Planning Sub Committee 11 December 2023

ADDENDUM REPORT FOR ITEMS

Reference No: HGY/2023/2137	Ward: Northumberland Park
Address: Tottenham Hotspur Stadium, 748 High Road, Tottenham, London N17 0AL	
Proposal: Minor Material Amendments to height, design, maximum floorspace and associated works to Plot 3 (Hotel / Residential development) of the hybrid planning permission HGY/2015/3000 (following previously approved amendments including HGY/2017/1183 to allow part residential (C3) use on Plot 3) for demolition and comprehensive redevelopment of the Northumberland Park Development Project through variation of Conditions A4 (Consented Drawings and Documents); A6 (Conformity with Environmental Statement) and Condition A7 (Maximum Quantity/Density) and D1 (Plot 3 specific drawings) under Section 73 of the Town and Country Planning Act (EIA development)	
Applicant: THFC	
Ownership: Private

Figure 7—4 Proposed location for future DEN connection into the Application Site

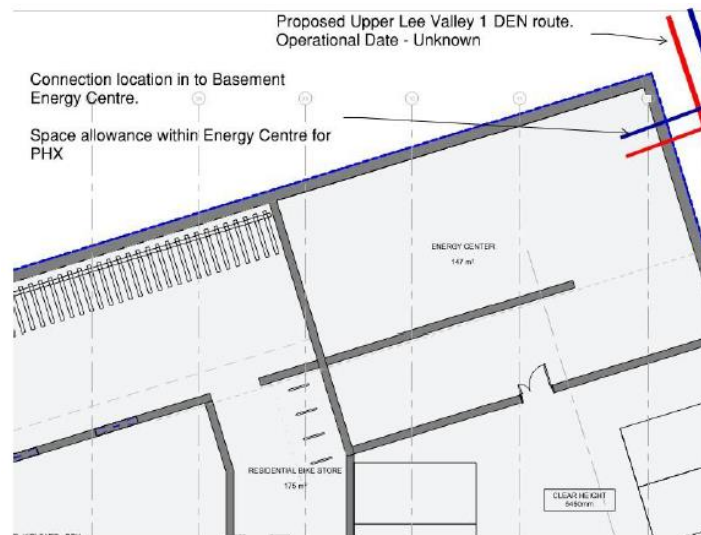
The Be Clean strategy to connect to the DEN in North Tottenham is generally acceptable. A site-wide carbon reduction of 32% is calculated under Be Clean, which is supported. Some evidence should be provided that the plant room is adequately sized for a substation.

The applicant will need to demonstrate that they will provide the following details prior to the commencement of construction:

- e) Buried pipe (dry and filled with nitrogen) to our specification from the GF plant room to a manhole at the boundary of their site and evidence of any

<p>obstructions in highway adjacent to connection point;</p> <p>f) A good quality network within the building – 60/40 F&R, <50W/dwelling losses from the network – ideally to an agreed standard in the S106;</p> <p>g) A clear plan for QA of the network post-design approval through to operation, based on CP1;</p> <p>h) A clear commercial strategy identifying who will sell energy to residents and how prices/quality of service will be set.</p> <p>The applicant’s alternative low-carbon heating strategy is to:</p> <ul style="list-style-type: none"> - Install air source heat pumps (ASHPs) for hotel rooms and amenity spaces with low temperature hot water for space heating, and fan coil units to amenity areas - Basement water source heat pumps to increase temperature of ASHP for domestic hot water to hotel and amenity areas - Include domestic hot water thermal stores - Provide future connection to DEN if it becomes available - Have a mid-level plant room ASHP serving residential flats with low-temperature hot water and domestic hot water through heat interface units. - The space for ASHPs should be safeguarded until it is confirmed the DEN is definitively not going to be available for connection. <p><u>Action:</u></p> <ul style="list-style-type: none"> - Clarify if the fan coil units would be in addition to the ASHP for hotel amenity. - Demonstrate plant room layout and space requirements for roof, mid-level, and thermal stores. - Please provide the alternative low-carbon heating scenario that shows the carbon reduction following the Energy Hierarchy, and state what carbon factor has been used. - Please identify on the plans where the alternative heating solution: the air source heat pumps will be located and how the units will be mitigated in terms of visual and noise impact. <p>Energy – Green As part of the Be Green carbon reductions, all new developments must achieve a minimum</p>
